Moorebank Avenue: MAAI Stage 1A

Post-Opening Road Safety Audit Report

May 2023

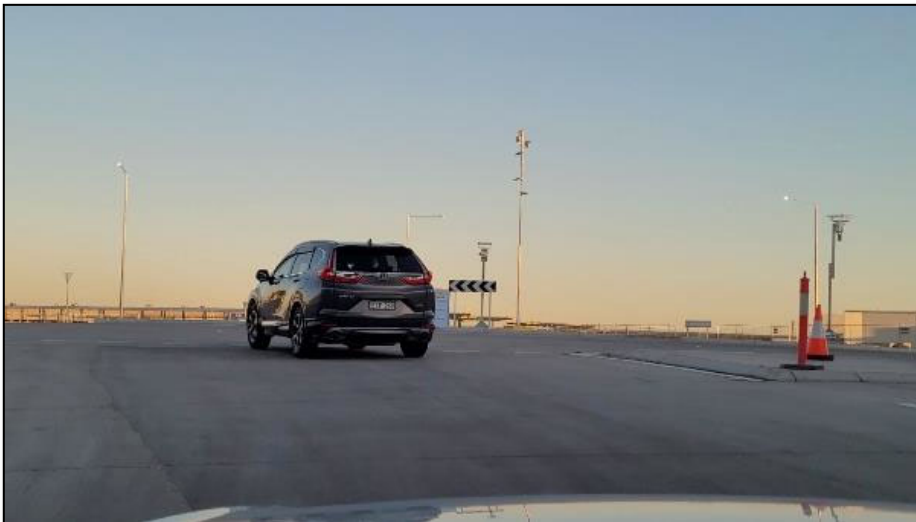
No.	Description of Road Safety Issue	Risk Rating	Road Safety Category	For completion by BMD	
				Action by	Response
1.	For the Western Ring Road approach to the roundabout near the BMD site office, there are two lanes on the northbound approach with only single lane exit lanes from the roundabout. Moreover, pavement markings show a through / right-turn in the median lane when there is no right-turn available – refer to <i>Photo 1 in Appendix A</i> . Consideration should be given to restricting travel to a single lane (similar to the rest of the Western Ring Road) in the kerbside lane to accommodate the large left-turn movement (Moorebank Precinct West (MPW) exiting to Moorebank Avenue). Similarly, for the BMD site office (eastern) leg approach to the roundabout, consideration should be given to restricting travel to a single lane.	Medium	Traffic management & operations / Intersections	LOGOS	<p>Noted; Required lane closure is outside BMD's LoW and forwarded to LOGOS for review and action.</p> <p>Logos – we will ask Knight Frank (who is responsible for this area) to adjust.</p> <p><u>Previously the western approach to the roundabout has had the left and through lane blocked to access through the use of cones. We would suggest this would limit the potential issue. As speeds are currently limited to 40 km/h this will help mitigate any risk. For right turns there is still the opportunity to do a u-turn and we do not believe this is a significant safety issue</u></p>

Commented [JT1]: (SMEC DS/JT): Agree with LOGOS/Northrop response

PHOTO 3: For travel along the Western Ring Road, the street lighting was not operational resulting in a darker section of road network in comparison with adjacent road sections.

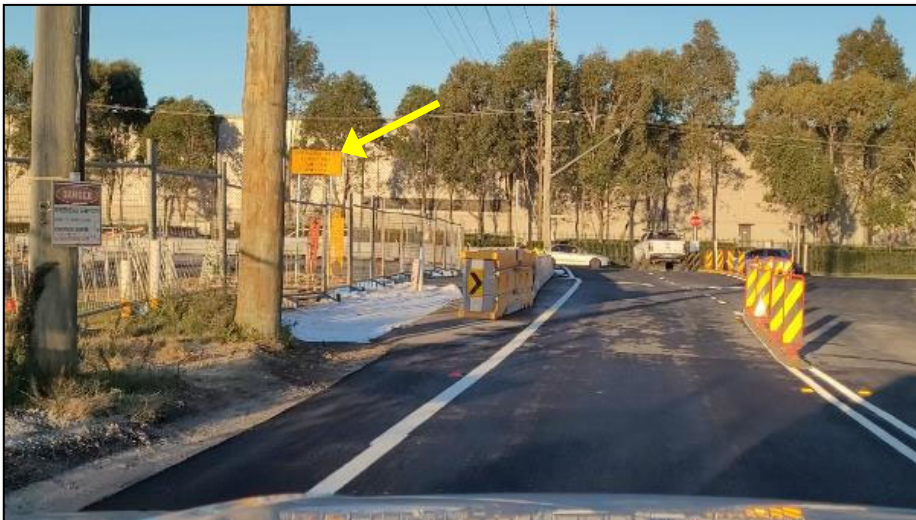
No.	Description of Road Safety Issue	Risk Rating	Road Safety Category	For completion by BMD	
				Action by	Response
5.	For travel along the Western Ring Road, the street lighting was not operational resulting in a darker section of road network in comparison with adjacent road sections – refer to <i>Photo 3</i> in <i>Appendix A</i> .	Low - Medium	Lighting	LOGOS	<p>Noted; It is outside BMD's LoW. BMD will notify LOGOS for review and action.</p> <p>Logos – This location is outside the extent of this RSA however we will advise maintenance and rectify.</p> <p>BMD to confirm lighting has been installed as per approved plans. Western ring road lighting should be provided once road is opened to public.</p>

Commented [JT5]: (SMEC DS/JT): Non-WAD/agree with response

PHOTO 5: For the Bapaume Road approach to Moorebank Avenue, the 'Stop' control sign is located on the right side of the approach only, which is non-standard and undesirable, especially for the majority left-turning traffic.

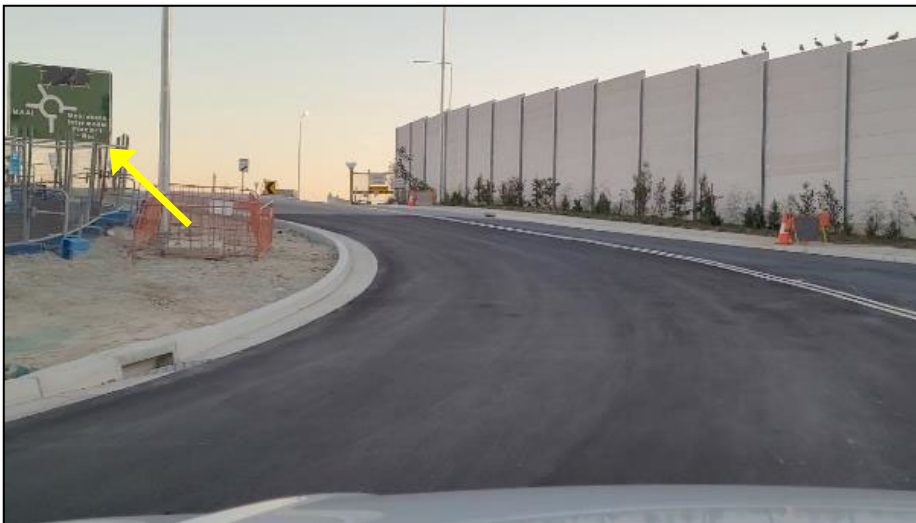
No.	Description of Road Safety Issue	Risk Rating	Road Safety Category	For completion by BMD	
				Action by	Response
8.	For the Bapaume Road approach to Moorebank Avenue, the 'Stop' control sign is located on the right side of the approach only, which is non-standard and undesirable, especially for the majority left-turning traffic – refer to <i>Photo 5</i> in <i>Appendix A</i> .	Low	Traffic signs	Northrop	<p>Noted; BMD will notify Designer Northrop for review.</p> <p>Logos – consider secondary sign on left.</p> <p>This has been rectified with the Stop sign being adjusted to provide additional offset to medians. An additional stop sign has been provided on the updated designs and advanced warnign sign provided on the left (MAAI-NRP-CP-DWG-4111_rev 11 drawing).</p>

Commented [JT8]: (SMEC DS/JT): Issue has been satisfactorily addressed
